MIL-C-27027(USAF)
AMENDMENT 3
15 February 1989
SUPERSEDING
AMENDMENT 2
12 March 1962

MILITARY SPECIFICATION

CLIP-IN SUBASSEMBLY MHU-29/C

FIGURE 4 STRUCTURAL LIMIT LOADS

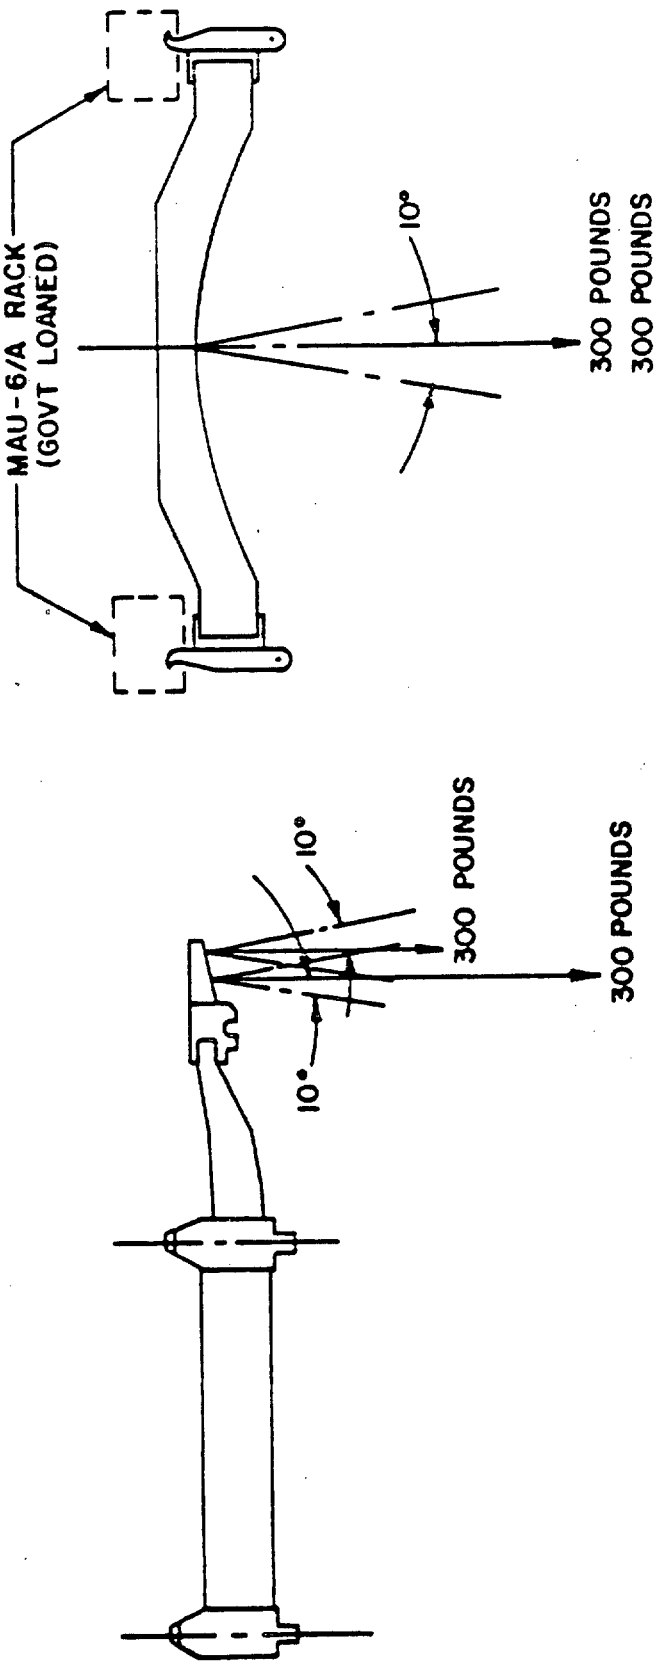
Figure 4 delete and substitute attached page 7, figure 4.

LIMIT LOADS TO BE APPLIED INDIVIDUALLY

LOAD ACT IN ANY DIRECTION IN AN ANGLE OF 10° WITH VERTICAL
